NATOMAS TRAIL MOUNTAIN

FIGURE 7-13a.
 CULVERT DETAILS

SURFACE DRAINAGE FACILITIES
TRAIL MOUNTAIN COAL MINE

STATE OF UTAH
NATURAL RESOURCES
Oil, Gas & Mining

Figure 1. Trapeziodal diversion cross-section to be used in runoff control for the Trail Mountain Mine.

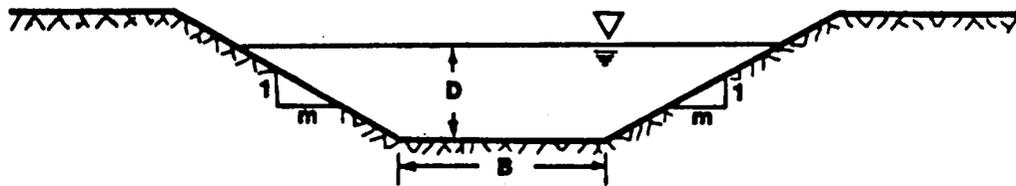
Division Hydrologist John Whitehead has reviewed your proposal, and as he has discussed with you, some problems exist. The primary one being the practicality of riprapping a disturbed area ditch which would need to be cleaned periodically. On October 11, 1984, you met with John and Tom Munson on-site to discuss the alternative measures for this ditch. The possibilities of asphaltting or concreting the stretch of ditch identified in your revision request were discussed. At present, the Division awaits your response to these alternative suggestions. No further action will be taken on this matter until we hear from you.
